**FINAL ENGINEERING PLANS  
FOR  
SUMMIT HOUSING GROUP - PUBLIC IMPROVEMENTS**

LYONS VALLEY PARK FILING NO. 8

**COVER SHEET  
SUMMIT HOUSING GROUP  
LYONS VALLEY PARK FILING NO. 8  
LYONS, COLORADO**

OVERLOT GRADING PLAN  
SUMMIT HOUSING GROUP  
LYONS VALLEY PARK FILING NO. 8  
LYONS, COLORADO

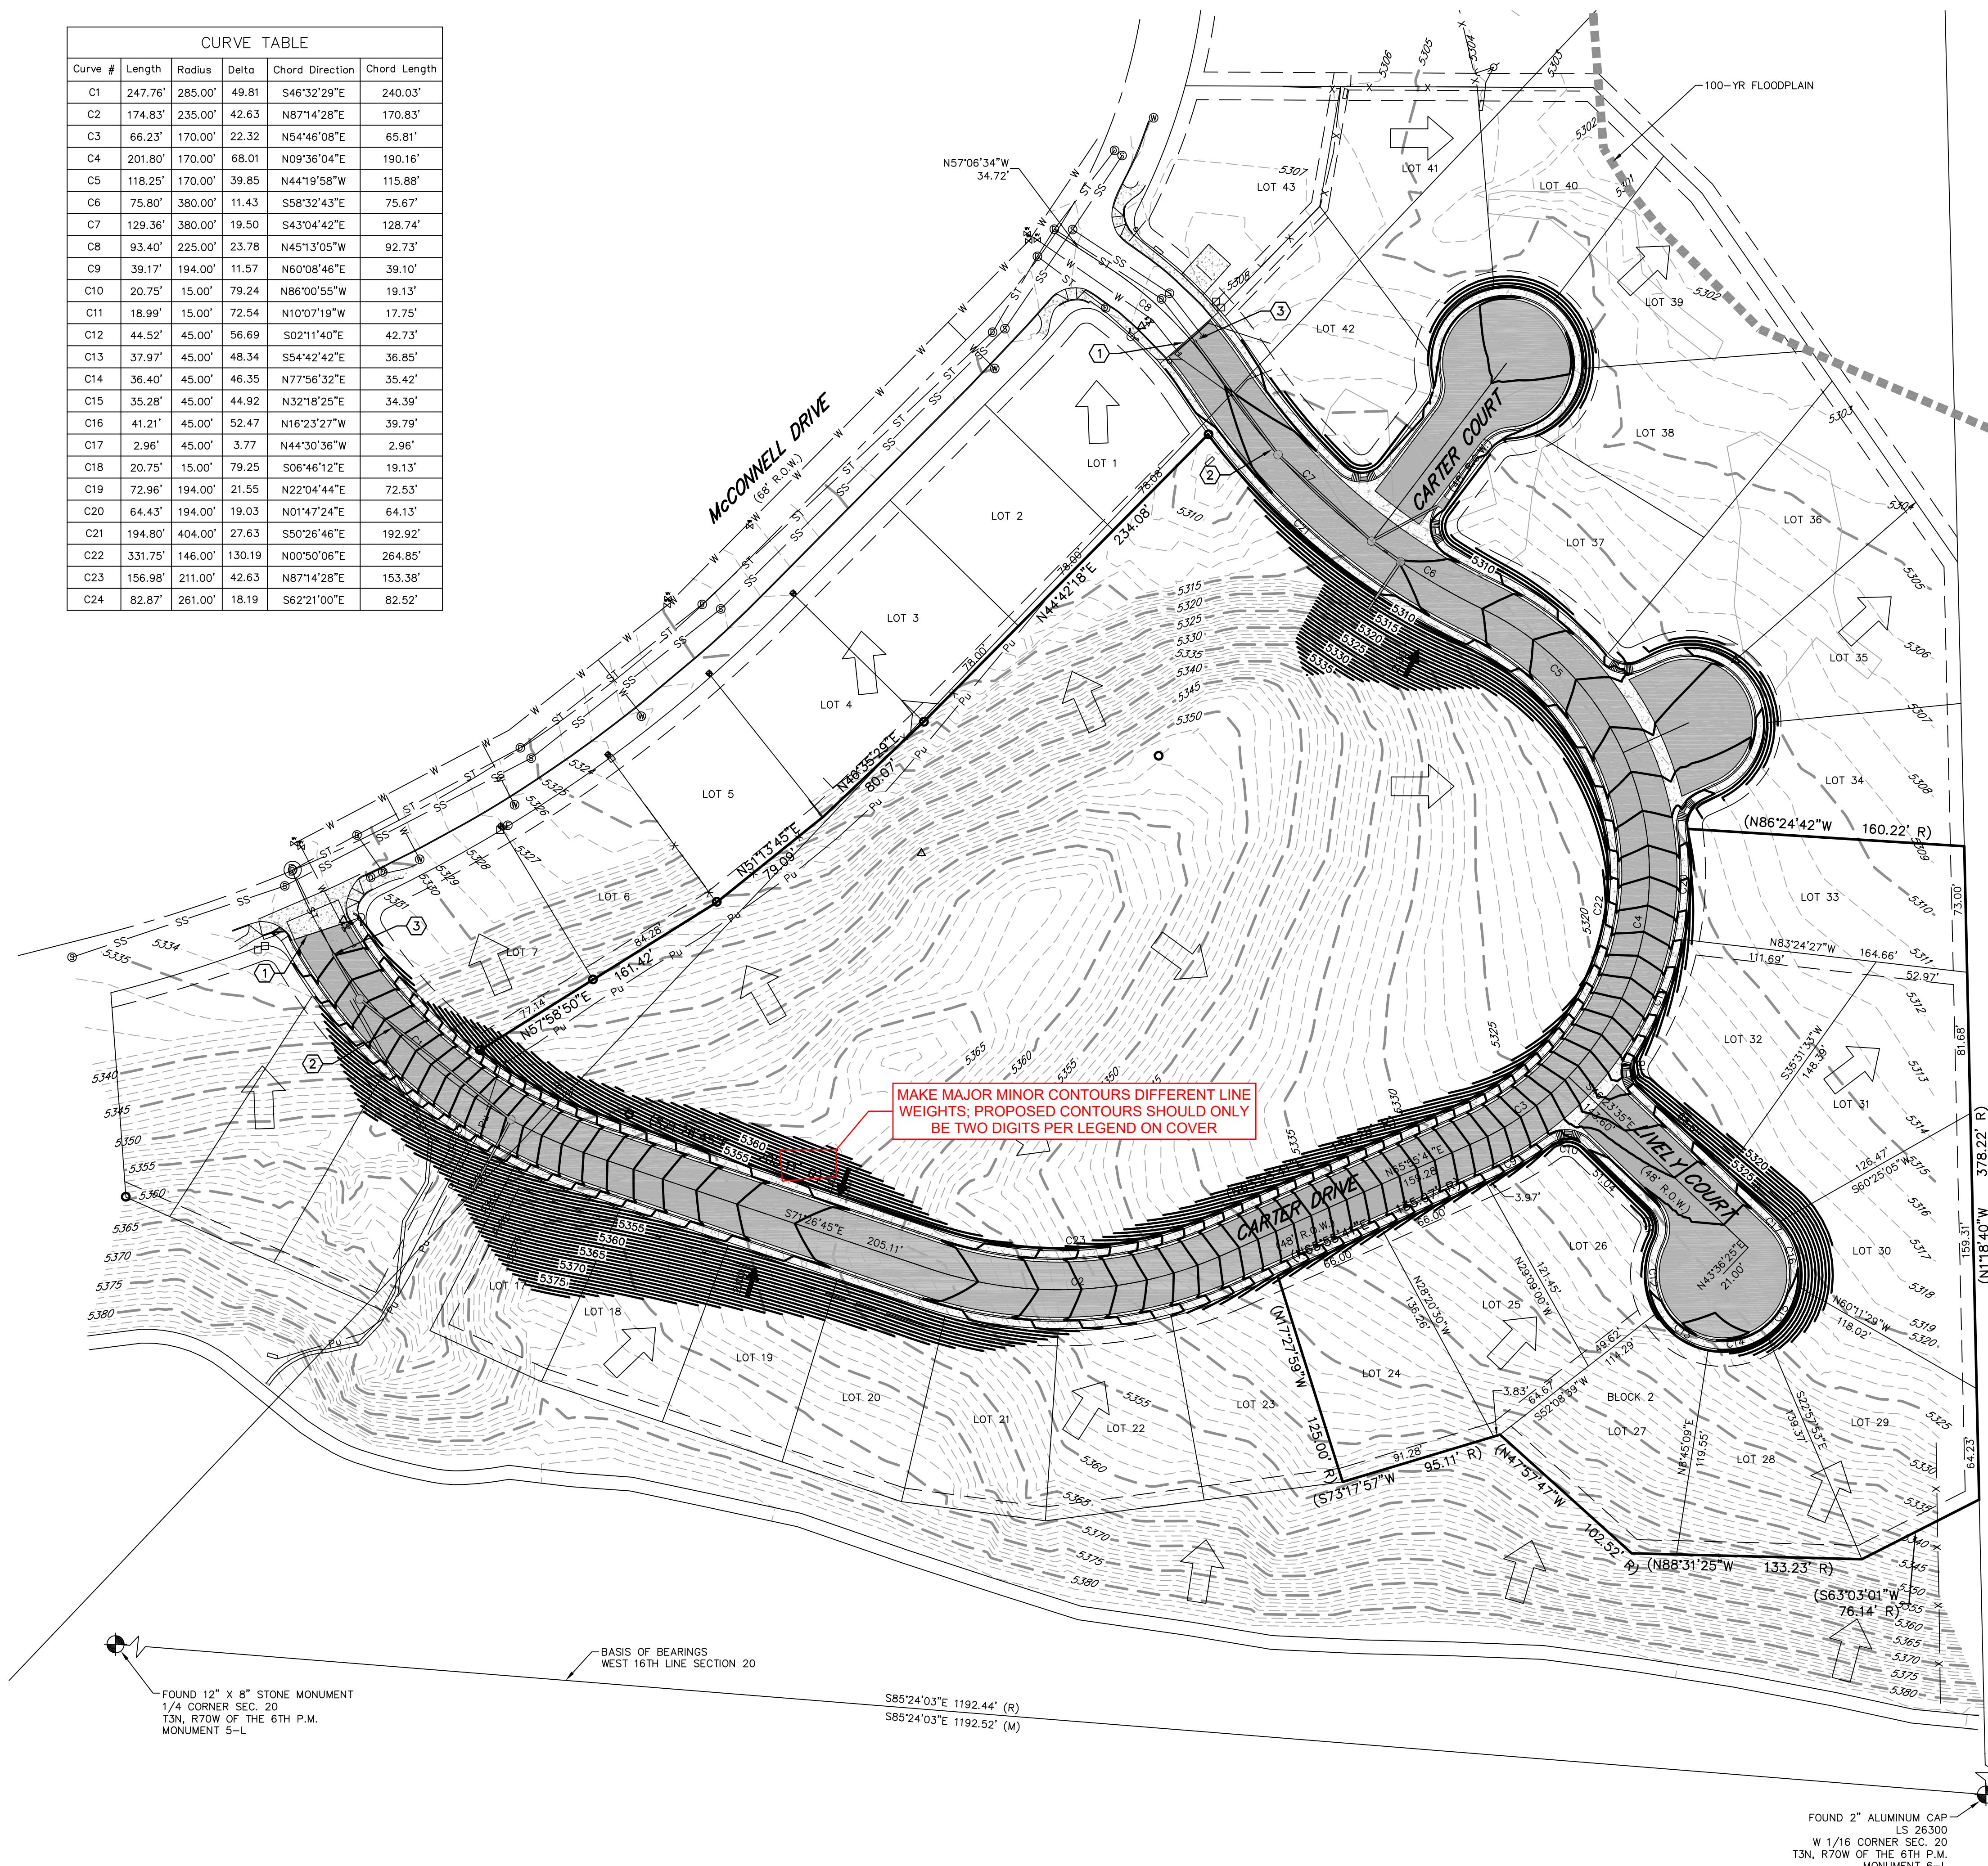
MASK ALL TEXT, KEYED NOTES, SLOPE ARROWS/LABELS (TYP: ALL SHEETS)

# WATER PLAN AND PROFILE SUMMIT HOUSING GROUP LYONS VALLEY PARK FILING NO. 8 LYONS, COLORADO

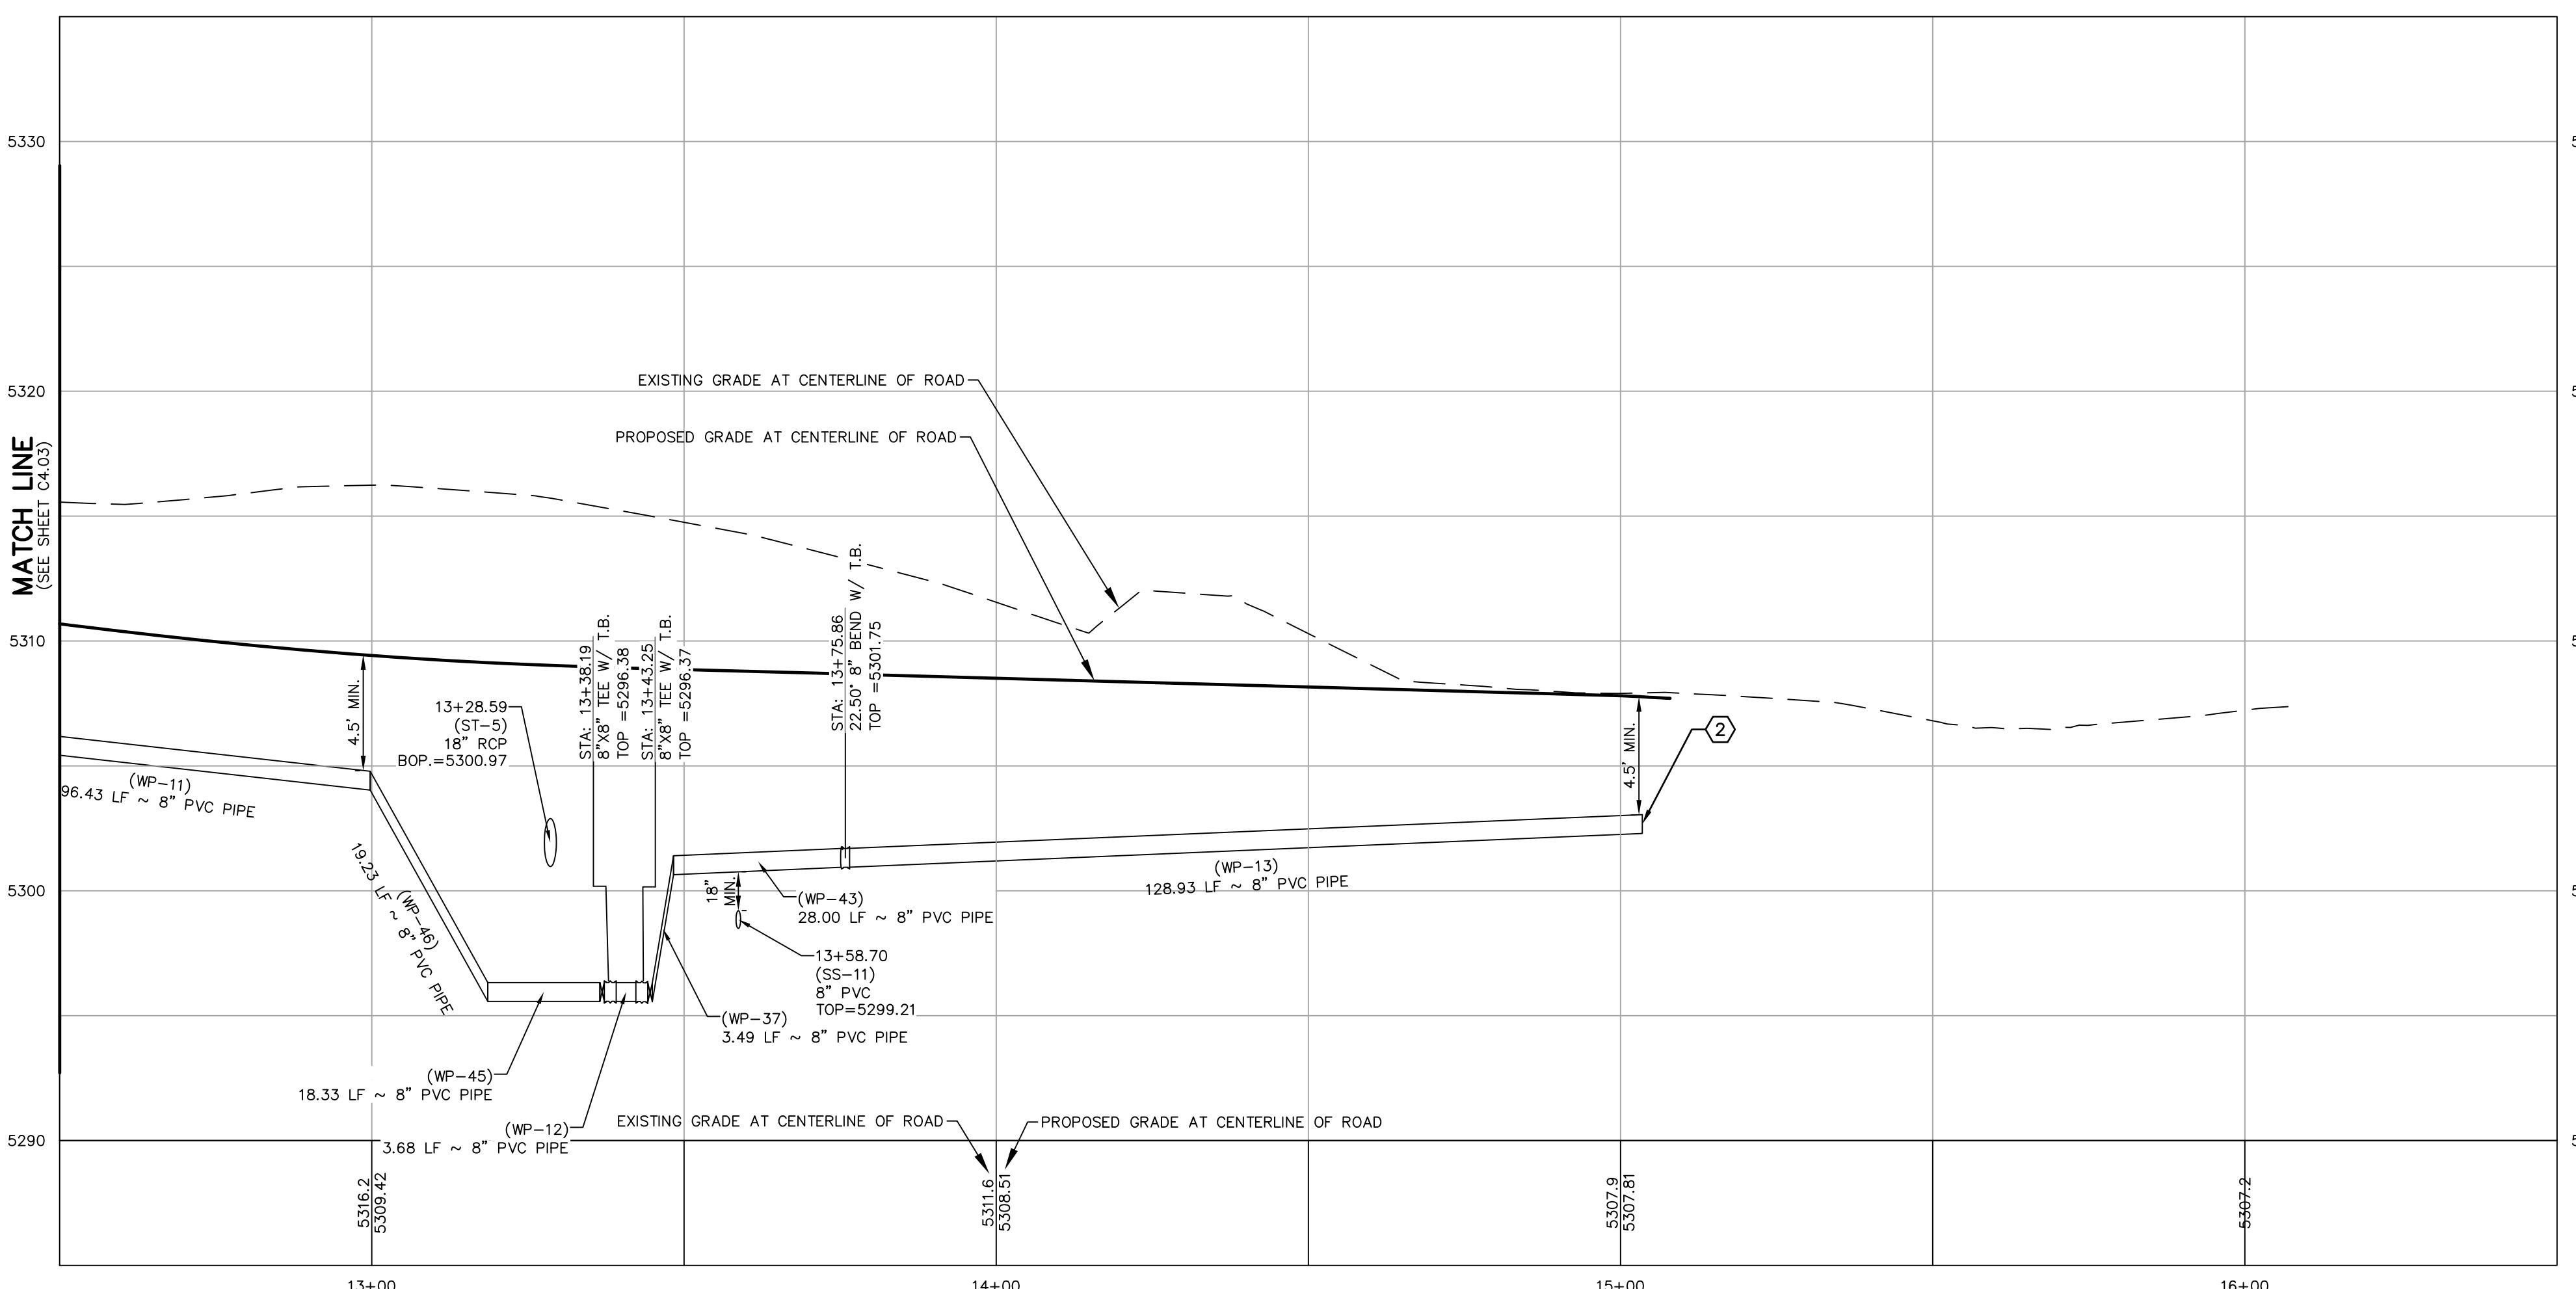
## ADD STREET NAMES
